TVA-BFN-TS-461

BROWNS FERRY NUCLEAR PLANT (BFN) - UNIT 1 - EXIGENT TECHNICAL SPECIFICATIONS (TS) CHANGE TS-461 - MODIFICATION OF RESTART LARGE TRANSIENT TESTING LICENSE CONDITION 2.(G)2

Proposed Licensed Condition Change (mark-up)

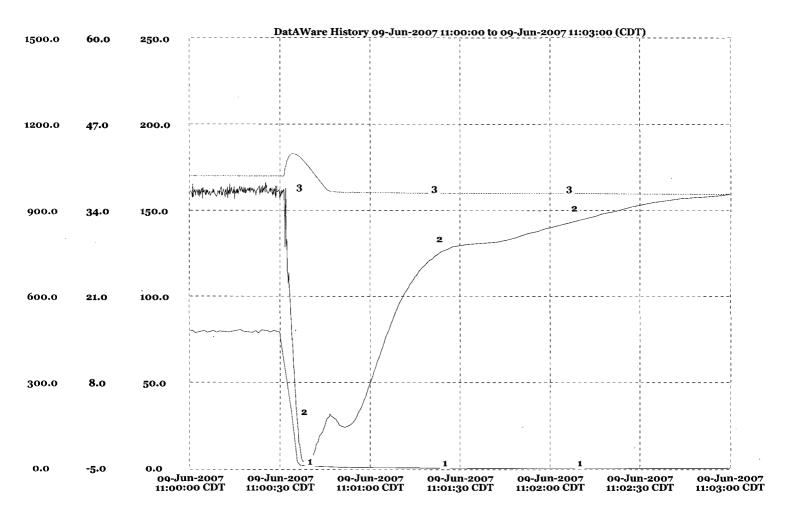
G. (1) During the power uprate power ascension test program and prior to exceeding 30 days of plant operation above a nominal 3293 megawatts thermal power level (100-percent OLTP) or within 30 days of satisfactory completion of steam dryer monitoring and testing that is necessary for achieving 105-percent OLTP (whichever is longer), with plant conditions stabilized at 105-percent OLTP, TVA shall trip a condensate booster pump, a condensate pump, and a main feedwater pump on an individual basis (i.e., one at a time). Following each pump trip, TVA shall confirm that plant response to the transient is as expected in accordance with previously established acceptance criteria. Evaluation of the test results for each test shall be completed and all discrepancies resolved in accordance with corrective action program requirements and the provisions of the power ascension test program.

Additionally, by October 31, 2007, TVA shall perform a turbine generator load reject test with plant conditions stabilized at 105-percent OLTP.
